STAFF REPORT
COMMUNITY DEVELOPMENT DEPARTMENT

HEARING DATE: 8/11/2020
TO: Mayor & City Council
FROM: Sonya Allen, Associate Planner
208-884-5533
SUBJECT: H-2020-0066 Apex – MDA, AZ, RZ
H-2020-0056 Apex Northwest – PP
H-2020-0057 Apex Southeast – PP
(to be marketed as “Pinnacle”)
LOCATION: MDA, AZ, RZ: generally located east of S. Meridian Rd. and north of E. Columbia Rd., in Sections 31 (S. ½ and NW ¼) and 32 (SW ¼), Township 3N., Range 1.E; and Sections 5 (NW ¼) and 6 (NE ¼), T.2N., R.1E.
PP (NW): NWC of S. Locust Grove Rd. & E. Lake Hazel Rd., in the SE ¼ of Section 31, T.3N., R.1E
PP (SE): SEC of S. Locust Grove Rd. & E. Lake Hazel Rd., in the NW ¼ of Section 5, T.2N., R.1E.

A. Master Plan (Revised)

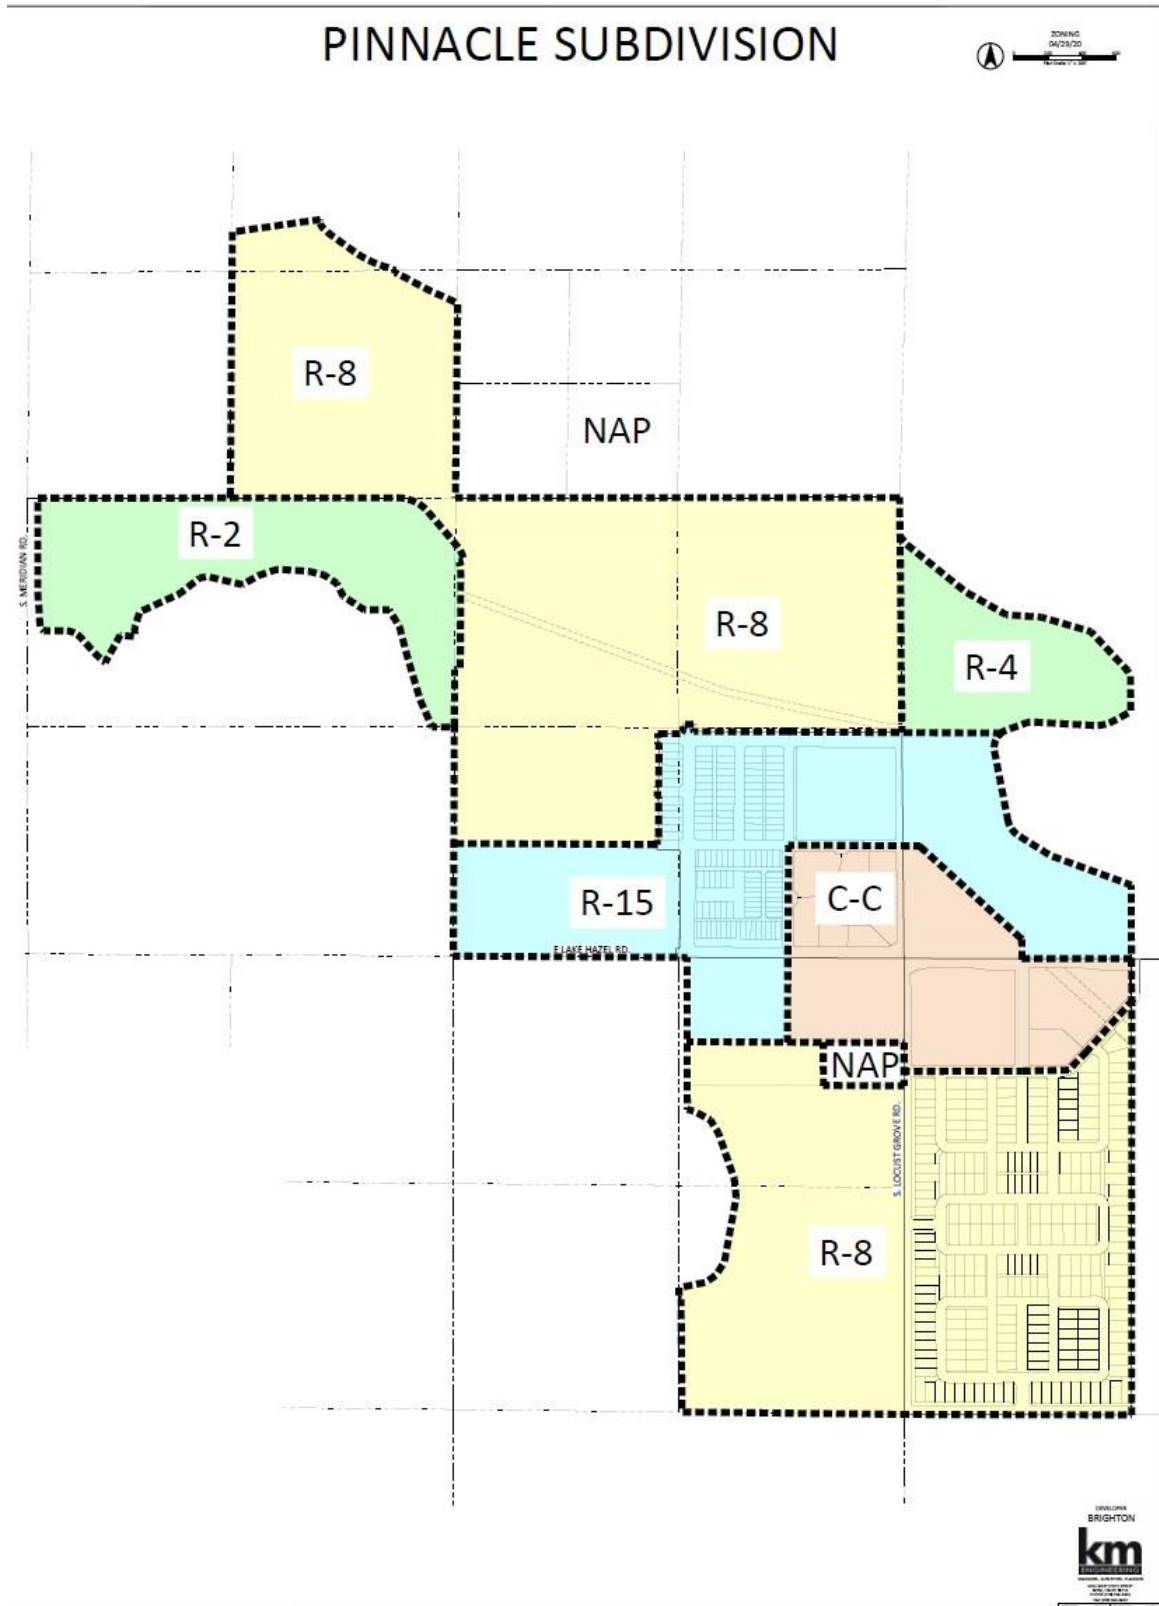
Staff recommends the proposed Master Plan is included in the new DA along with the provisions for future development listed in Section IX.A.1 to ensure compliance with the MU-C FLUM designation.

- d. Prior to development of the Mixed Use – Community (MU-C) designated areas shown on the Master Plan as “future development,” the Development Agreement shall be amended to include a conceptual development plan that demonstrates consistency with the general guidelines for Mixed Use developments and specifically the MU-C designation (see pgs. 3-13 and 3-15 thru 3-16).

APEX Northwest Phasing
Conceptual / Subject to Change

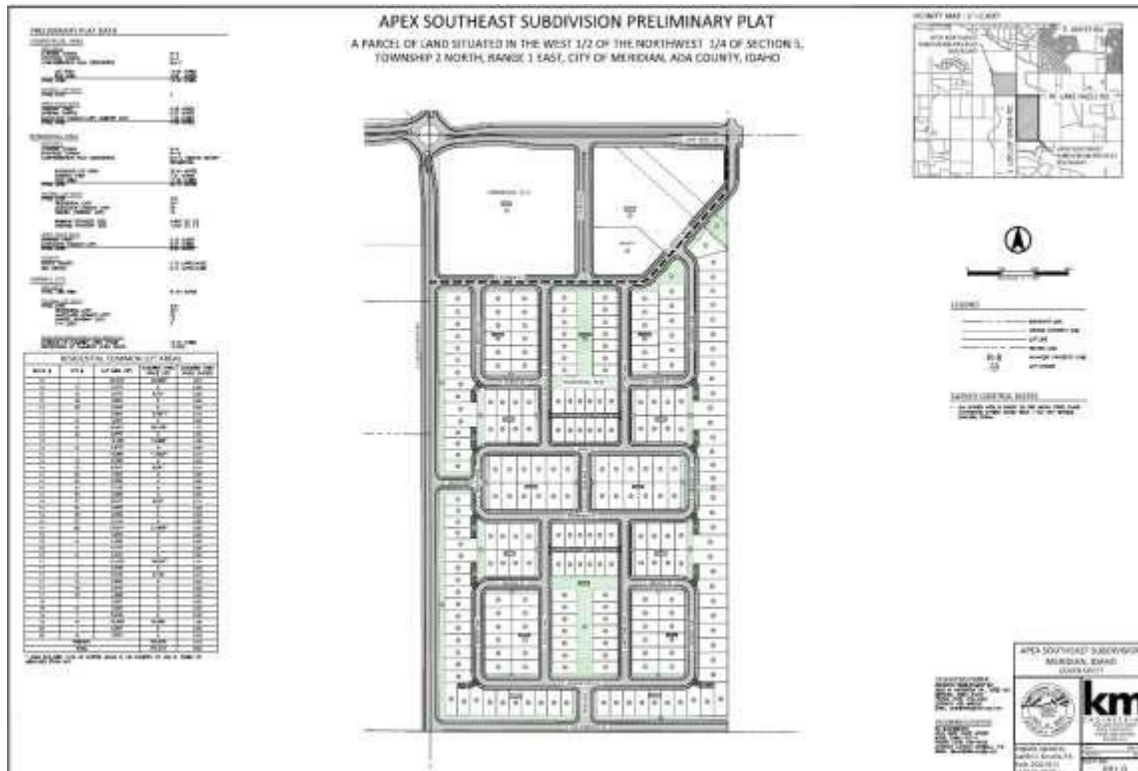
Apex Northwest consists of 120 single-family residential buildable lots for the development of 88 detached and 32 attached dwelling units, 11 commercial buildable lots and 14 common lots on 41.75 acres of land in the C-C and R-15 zoning districts. The minimum lot size proposed is 2,863 square feet (s.f.) with an average lot size of 3,885 s.f. The gross density proposed is 5.62 units/acre with a net density of 11.21 units/acre. The subdivision is proposed to develop in 3 phases as shown on the Phasing Plan in Section VIII.D.

E. Landscape Plan (date: 4/30/2020)

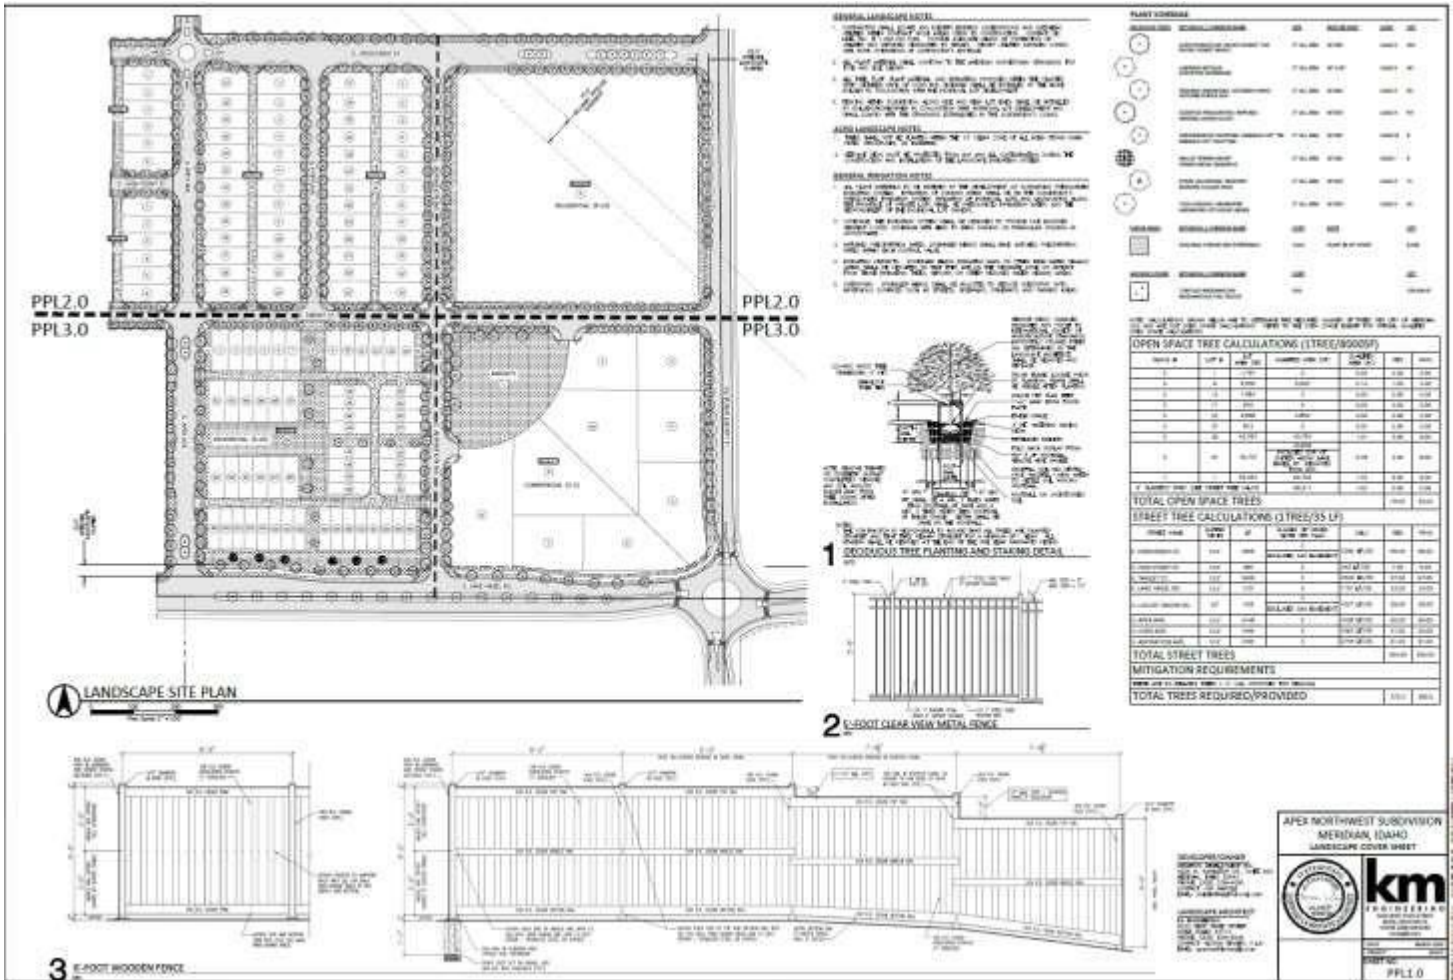
Based on the area of the residential portion of Apex Northwest (31.52 acres), a minimum of one (1) qualified site amenity is required to be provided. A gazebo is proposed as an amenity in Lot 32, Block 5 as an amenity; **Staff recommends tables and benches are also provided as required for a “picnic area” amenity.** A community center and amphitheater are also proposed as public amenities in the adjacent commercial portion of the development and a swimming pool is depicted on the Master Plan off-site on the adjacent property to the north; however, these do not qualify as amenities for the residential portion of the development proposed to be platted with this application.

Based on the residential area of the Apex Southeast plat (63.18 acres) zoned R-8, a minimum of three (3) qualified site amenities are required to be provided. **A swimming pool and children’s play equipment are proposed in a central common area and pedestrian pathways (multi-use pathway along E. Lake Hazel Rd. and internal pathways) are proposed as amenities in this development in accord with UDC standards. A detail of the children’s play equipment should be submitted with the final plat application.**

4. The landscape plan submitted with the final plat application for Apex Northwest shall be revised as follows:
 - a. Depict multi-use pathways in accord with the Pathways Master Plan as required by the Park's Dept. in Section IX.E. Landscaping shall be depicted along either side of the pathways as set forth in UDC 11-3B-12C.

- f. Depict a gazebo with tables and benches as an amenity in Lot 32, Block 5; include a detail of the gazebo.
5. The landscape plan submitted with the final plat application for Apex Southeast shall be revised as follows:

- a. Depict multi-use pathways in accord with the Pathways Master Plan as required by the Park's Dept. in Section IX.E. Landscaping shall be depicted along either side of the pathways as set forth in UDC 11-3B-12C.

- g. Depict the children's play equipment proposed in the central common area; include a detail of the play equipment.
 6. Future development shall be consistent with the minimum dimensional standards listed in UDC Tables 11-2A-6, 11-2A-7 and 11-2B-3 for the R-8, R-15 and C-C zoning districts respectively.
